Stage 1 Road Safety Audit and Designer's Response

Report title:	Stage 1 Road Safety Audit Response
Date:	25 April 2025
Document reference and revision	033_8230679_AD_RSA_Response
Prepared by:	Glanville Consultants
On behalf of:	Bloor Homes Southern

Project:	8230679 – Land South of Mortimers Lane, Fair Oak
Report title:	Stage 1 Road Safety Audit Response

Drawing No. 8230679/6103 Rev I

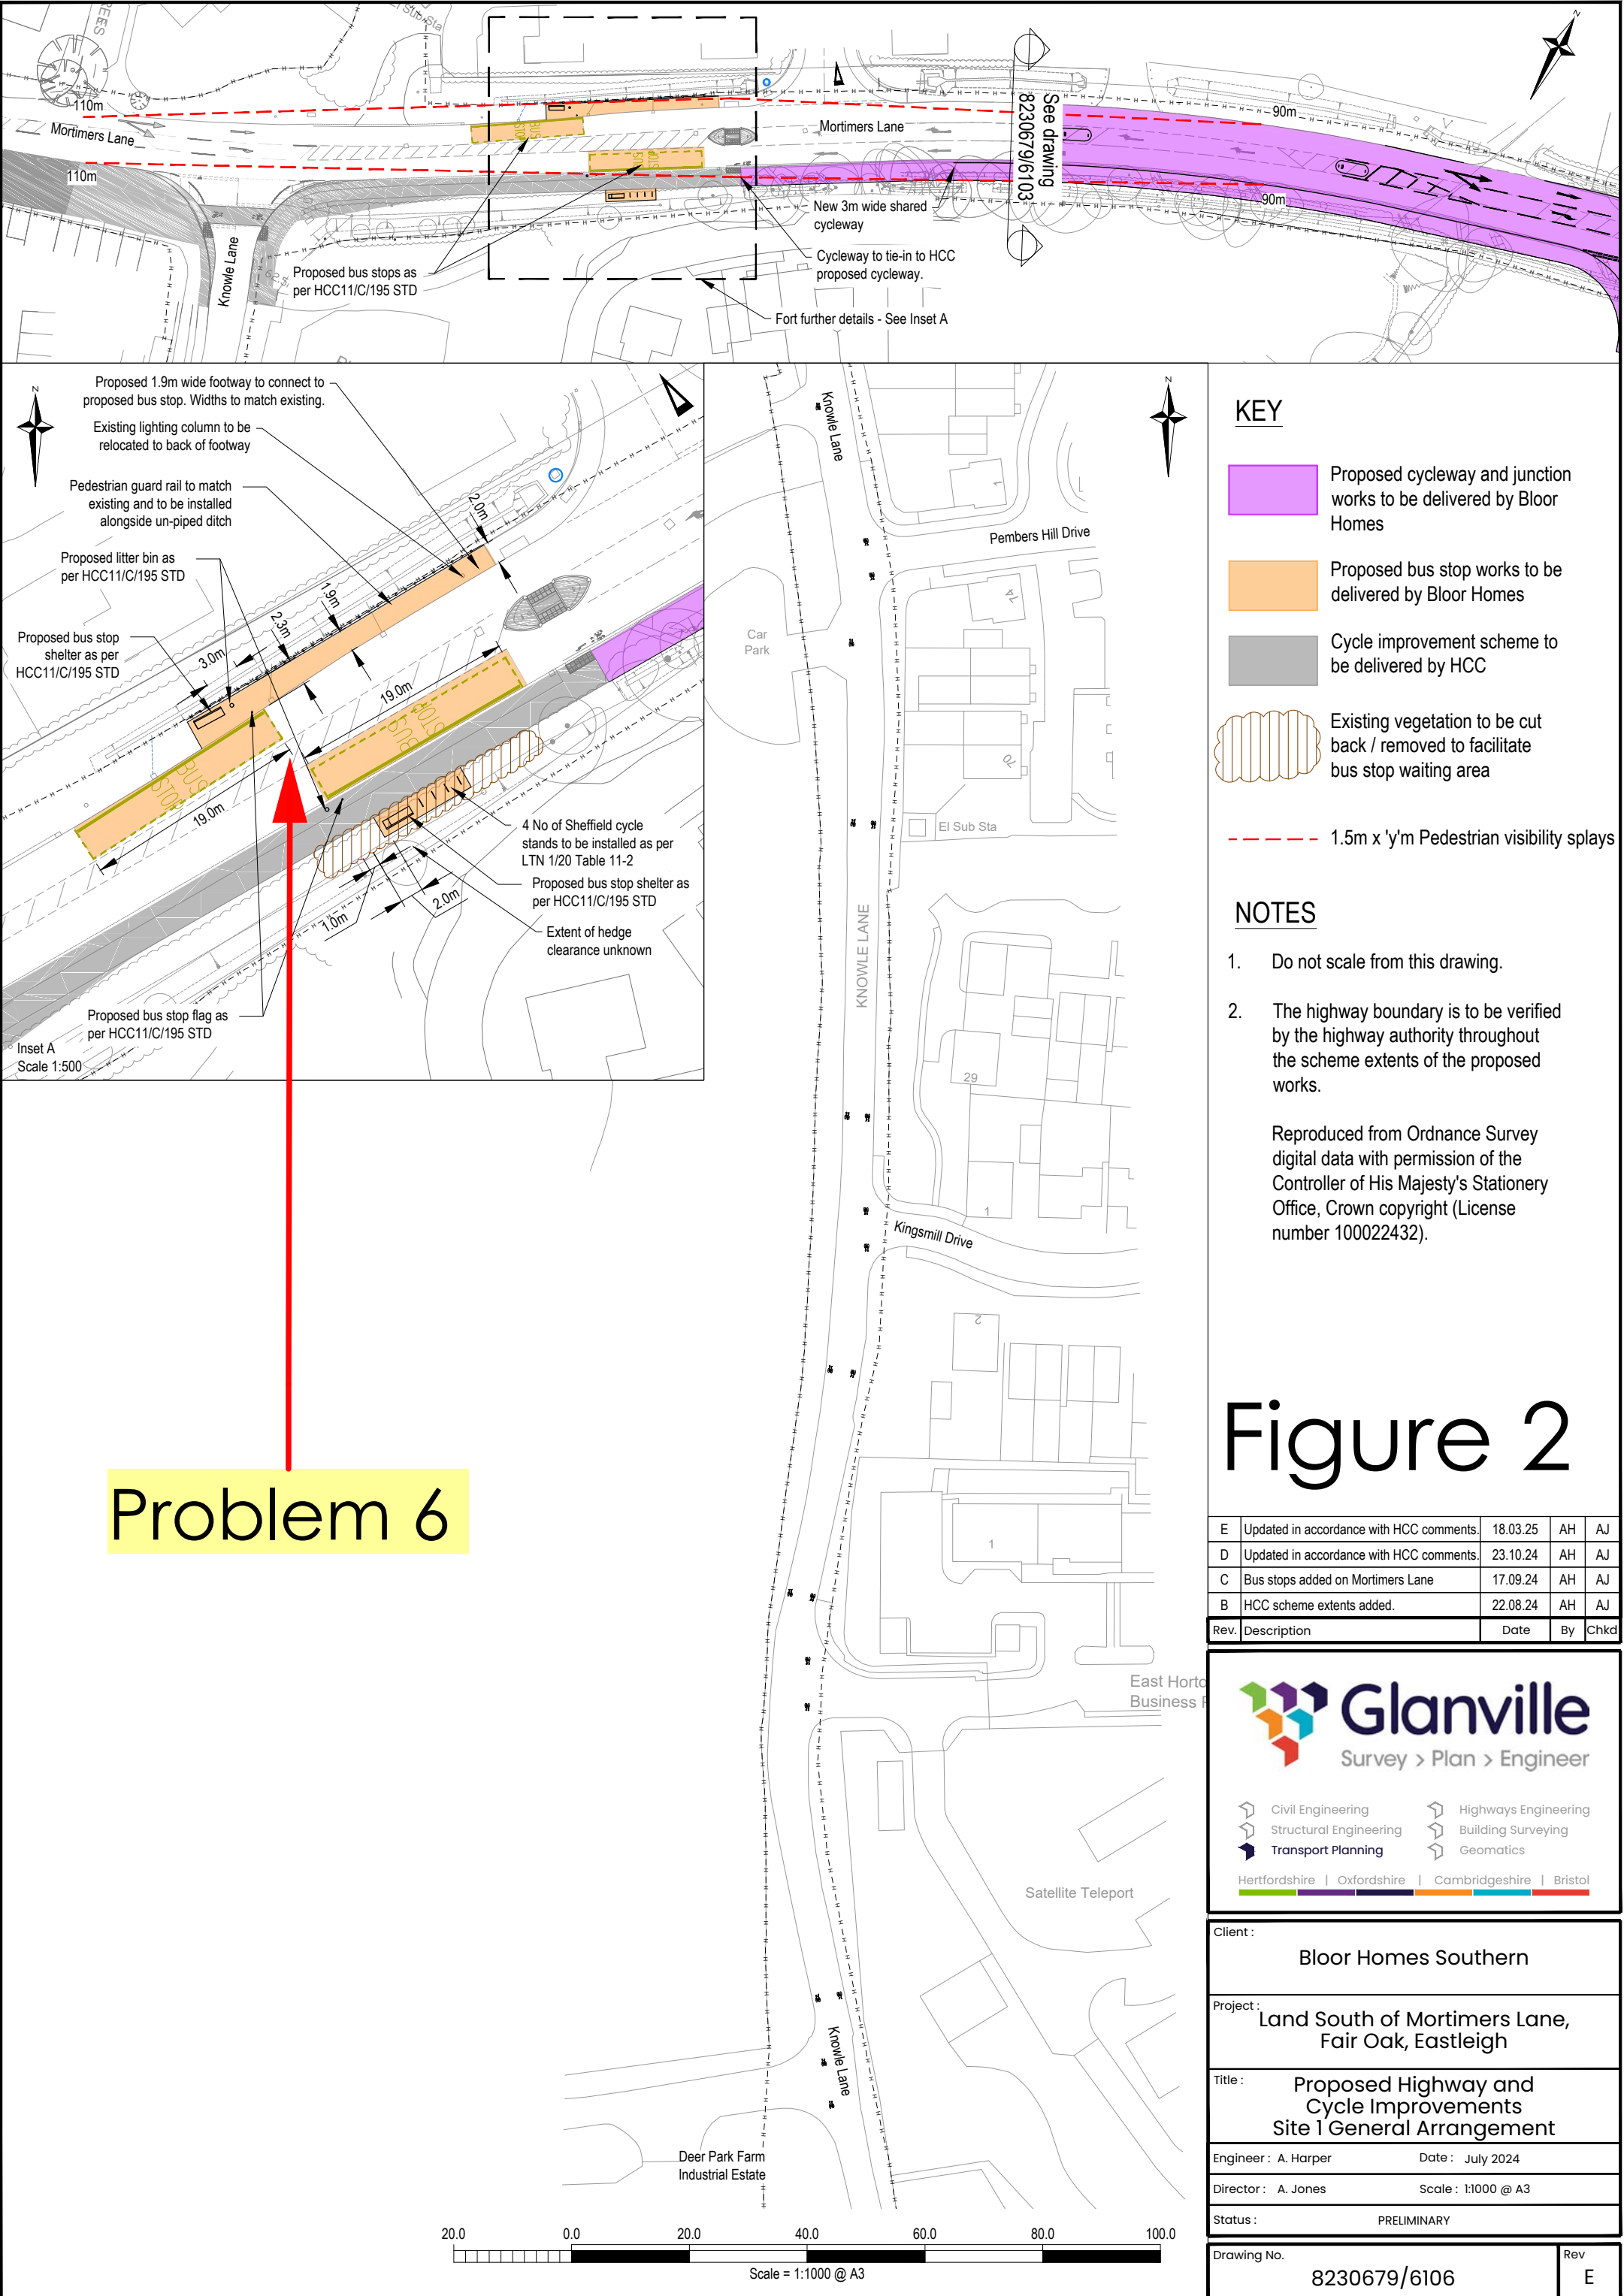
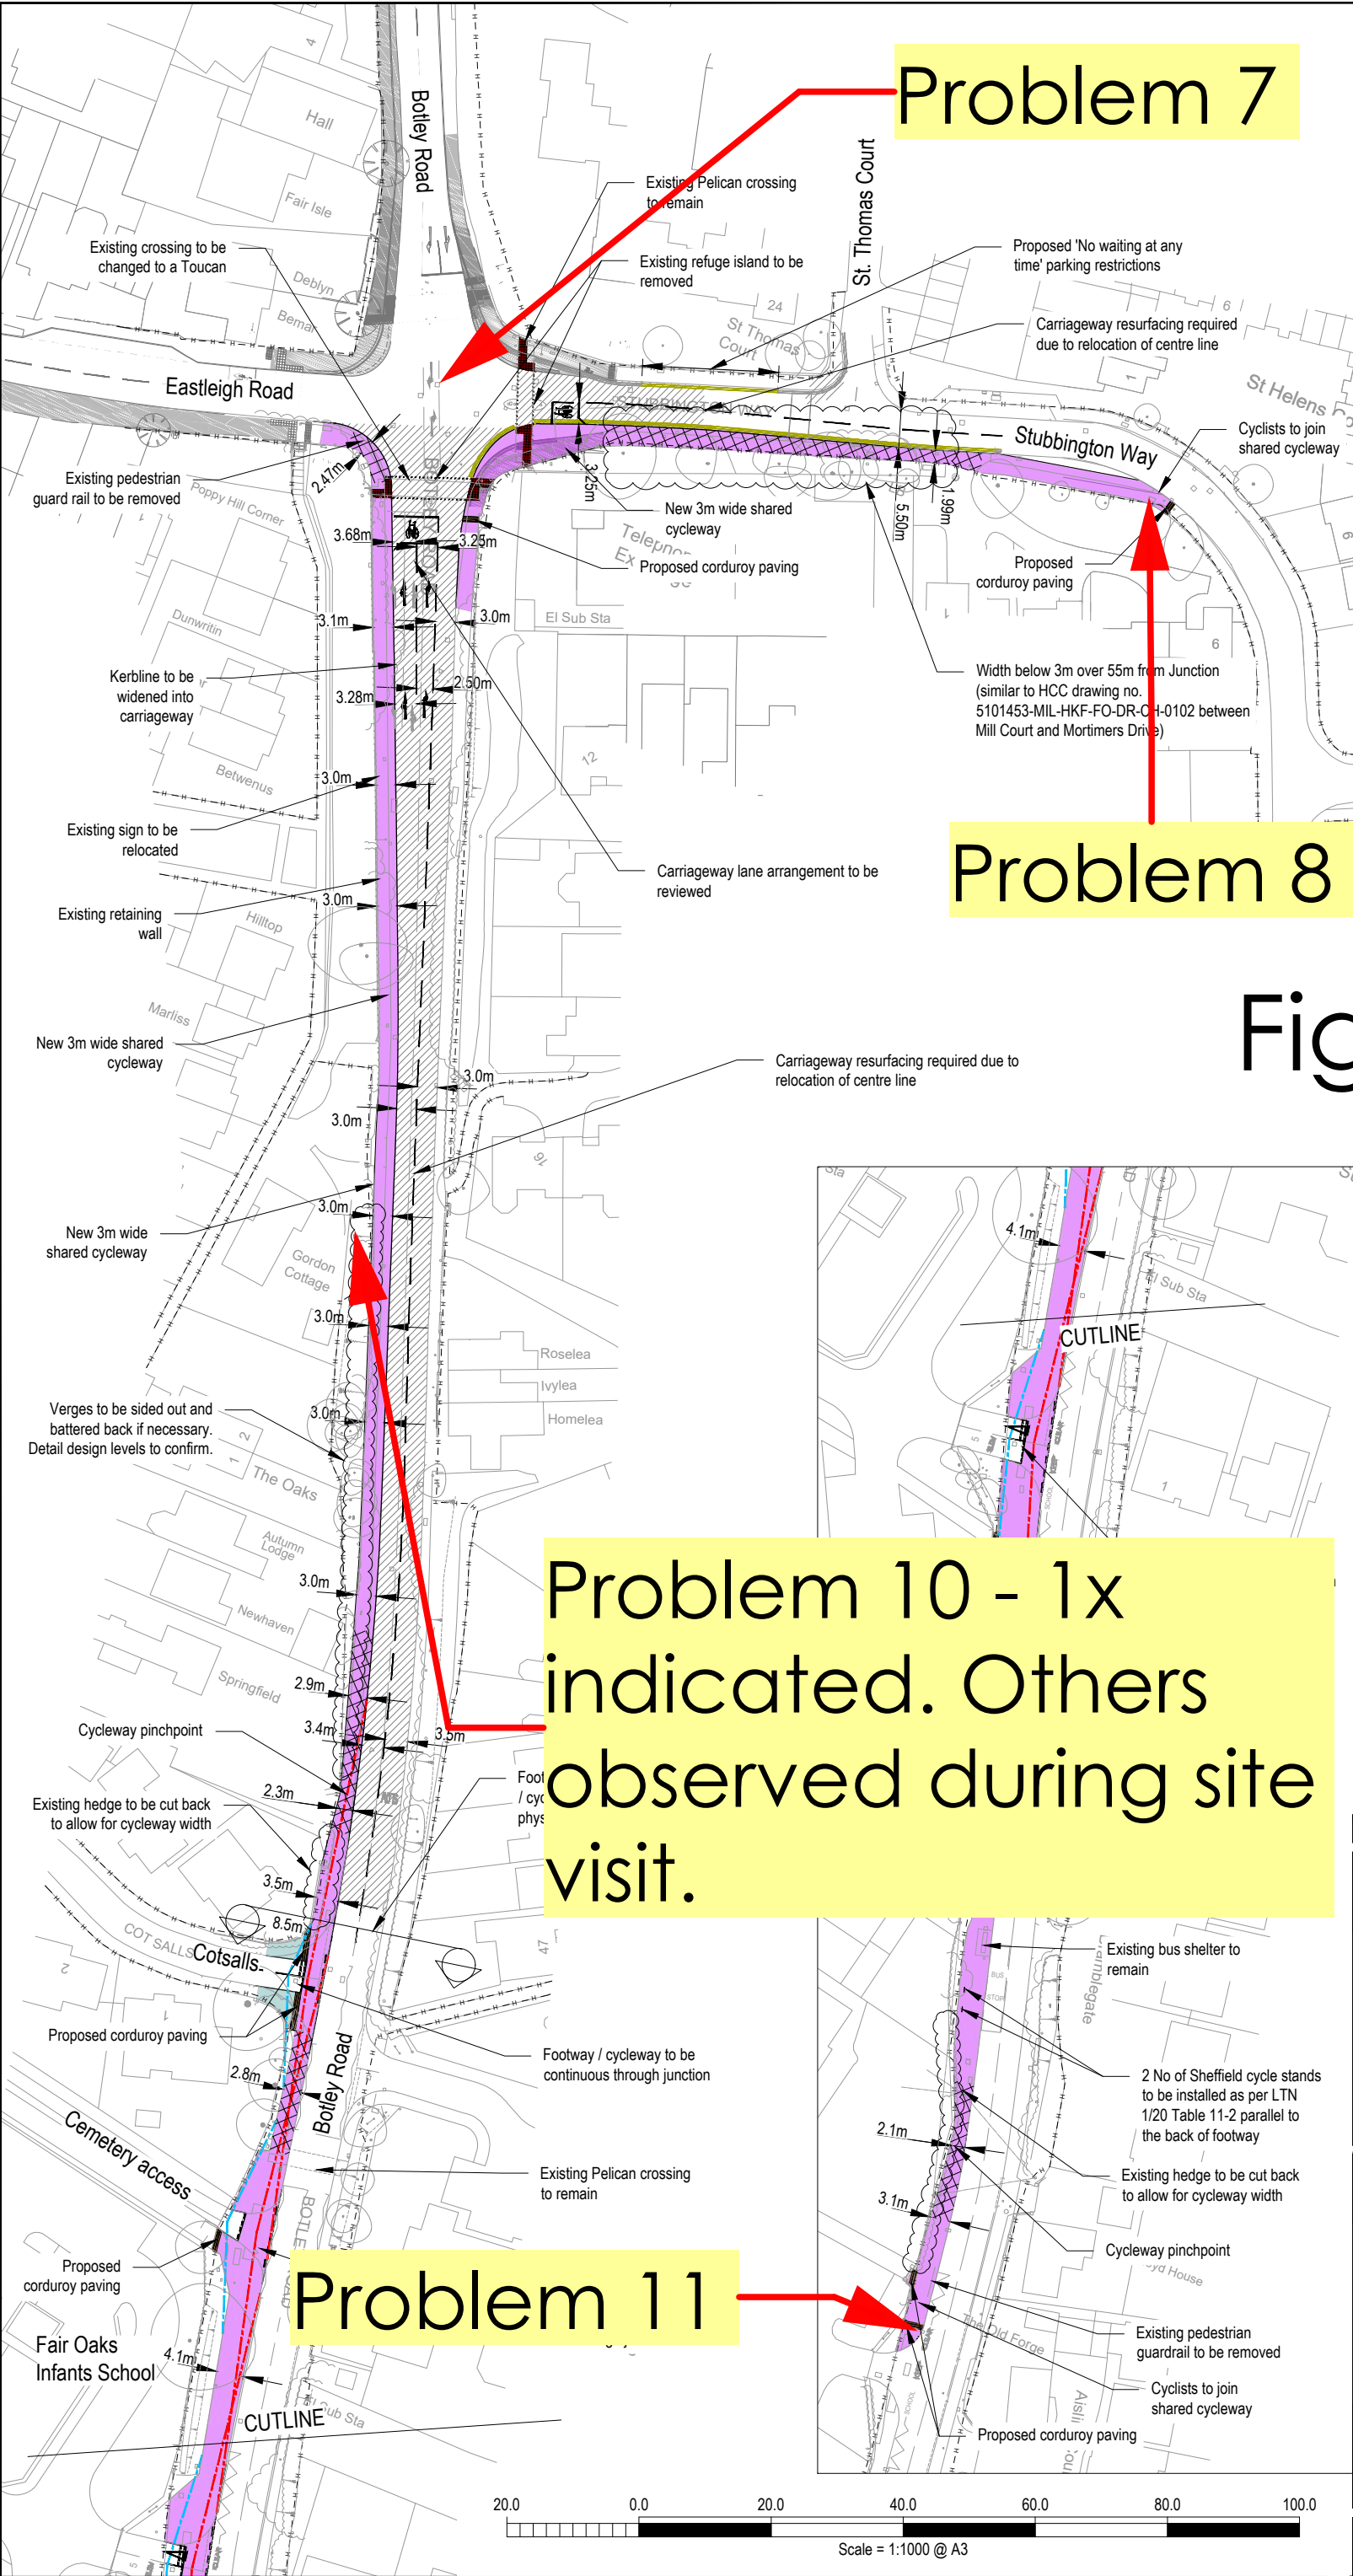
Location: Access to Little Dower House (Drawing No. 8230679/6103).

It is recommended that the overall junction arrangement should be modified to allow these opposing manoeuvres to take place. This may include, but not be limited to, modifying the proposed ghost island to allow for the introduction of a gap (similar in length to existing) for a right turning vehicle to wait prior to entering Little Dower House.

Location: Proposed site access (Drawing No. 8230679/6103).

Location: Proposed site access (Drawing No. 8230679/6103).

In respect of 'warnings', it is recommended that hazard (corduroy) paving should be provided at the change from shared facility to footway only.

Location: Proposed footway link to the east of the site access (Drawing No. 8230679/6103).

Location: Proposed footway link to the east of the site access (Drawing No. 8230679/6103).

The proposed footway link to the east of the site access will provide pedestrians with a more accessible route to / from existing Footpath Refs. 085/18/1 and 085/19/4, both of which are located on the northern side of Mortimers Lane. However, pedestrians wishing to access either Footpath, via the new link, will need to negotiate a proposed full-height kerb in the process. This may lead to trips and falls with possible personal injury occurring. (Note: As indicated in the below photograph the visible, trodden route suggests that Footpaths are being used.).

RSA Problem Ref.	RSA Problem	RSA Recommendation	Design Organisation Response	Overseeing Organisation Response	Agreed RSA Action
1	Based on the information made available to the Audit Team, vehicles comprising residents, visitors and deliveries etc. will continue (and be permitted) to turn right from Mortimers Lane to Little Dower House after the ghost island and site access have been completed. To date the right-turn manoeuvre to this property has been undertaken via an informal ghost island, which essentially comprises a gap in the central hatching. Any vehicle waiting to turn right within this gap does not obstruct westbound through traffic movements. With the introduction of the proposed site access the existing gap will cease to exist, being replaced by the proposed ghost island right-turn lane. There is a concern that drivers wishing to turn right to Little Dower House may continue to enter the westernmost end of the proposed ghost island, despite the adjusted position of the bifurcation arrow. This may lead to head-on vehicle / vehicle collisions with possible personal injury occurring.	It is recommended that the overall junction arrangement should be modified to allow these opposing manoeuvres to take place. This may include, but not be limited to, modifying the proposed ghost island to allow for the introduction of a gap (similar in length to existing) for a right turning vehicle to wait prior to entering Little Dower House.	As referenced in the introduction to this report, the proposed site access has already been subject to an in-principle Departure from Standard (DfS) application, which sought to reduce the 'X' distance to 2.4 metres. In its written response to that DfS, Hampshire County Council (HCC) acknowledged the context of the access arrangement, stating: <i>"It is stated in Paragraph 2.29.1 of CD123 that direct access should be avoided where possible. Given that this is an existing access, and the site frontage is directly opposite this access, the access could not be fully avoided. However, measures have been taken to ensure that safe access is provided to the proposed development and the Little Dower House access."</i> Since that DfS was submitted, no changes have been made to the site access design. The proposals, including the revised road markings and taper arrangement that addressed concerns raised in the original RSA, have been reviewed by HCC on two separate occasions: Firstly, through the DfS process, where the reduced X-distance and site access configuration were accepted in principle. Secondly, during the statutory consultation on the planning application, where no objection was raised to the access arrangements in HCC's formal response following review of the Transport Assessment. While a full DfS submission will be required at detailed design stage, the current

RSA Problem Ref.	RSA Problem	RSA Recommendation	Design Organisation Response	Overseeing Organisation Response	Agreed RSA Action
			access layout has already been acknowledged as providing a safe and appropriate solution in line with HCC TG guidance. HCC should therefore be expected to reaffirm their previous acceptance of the proposed access arrangements, including provision for the Little Dower House access.		
2	The visibility splay to the left, from the proposed site access, is shown to pass behind the proposed 3 metres shared footway / cycleway. The length of visibility splay which is shown to be behind the new shared facility is approximately 45 metres. There is a concern that this obstruction may lead to vehicles, which are turning right out of the site, entering Mortimers Lane into the path of an eastbound vehicle with possible collisions occurring with personal injury.	It is recommended that the existing hedgerow along the affected length should be extensively trimmed back, allowing for future irregular growth.	Drawing 8230679/6103_J identifies the extent of vegetation to be removed to achieve the visibility splay to the left, along with an allowance for an additional 300mm of trimming behind the visibility splay to ensure future growth is minimised.

4	Where the proposed footway link crosses existing accesses, pedestrians may have to negotiate a full-height kerb. This may lead to pedestrian trips and falls with personal injury occurring.	It is recommended that an uncontrolled pedestrian crossing facility, incorporating at the very least dropped kerbing laid flush, should be provided where existing accesses sever the proposed footway link.	Drawing 8230679/6103_J noted that the 1.8m footway hatched in blue would only be delivered in the event that the Mortimers Farm development did not come forward. As the Mortimers Farm development is now coming forward, it is not the developer's responsibility to deliver improvements to the footway.

RSA Problem Ref.	RSA Problem	RSA Recommendation	Design Organisation Response	Overseeing Organisation Response	Agreed RSA Action
			Nonetheless, a section of dropped kerb and tactile paving has been proposed over the Mortimers Farm access.		
5	The proposed footway link to the east of the site access will provide pedestrians with a more accessible route to / from existing Footpath Refs. 085/18/1 and 085/19/4, both of which are located on the northern side of Mortimers Lane. However, pedestrians wishing to access either Footpath, via the new link, will need to negotiate a proposed full-height kerb in the process. This may lead to trips and falls with possible personal injury occurring. [Note: As indicated in the below photograph the visible, trodden route suggests that Footpaths are being used.]	It is recommended that a short length of dropped kerbing should be provided along the proposed footway link on the southern side of Mortimers Lane to allow pedestrians to transfer between this and the existing Footpaths. This is especially important given that the northern verge is currently used as a route to these Footpaths (as evidenced in the above photograph) but a length of the same verge will be converted to carriageway when delivering the proposed site access. Locally the existing verge should also be regraded on the northern side of Mortimers Lane to facilitate pedestrian access to / from these public rights of way.	Drawing 8230679/6103_J noted that the 1.8m footway hatched in blue would only be delivered in the event that the Mortimers Farm development did not come forward. As the Mortimers Farm development is now coming forward, it is not the developer's responsibility to deliver improvements to the footway. Nonetheless, a dropped kerb crossing has been proposed to Footpath 085/8/1, along with re-grading of the verge on the northern side of Mortimers Lane, given some of the existing verge on the northern side of Mortimers Lane will be removed to form the site access thus removing a desire line for pedestrians. As no footway is proposed east of the Mortimers Farm access in the vicinity of Footpath 085/19/4, no crossing is proposed in this location.
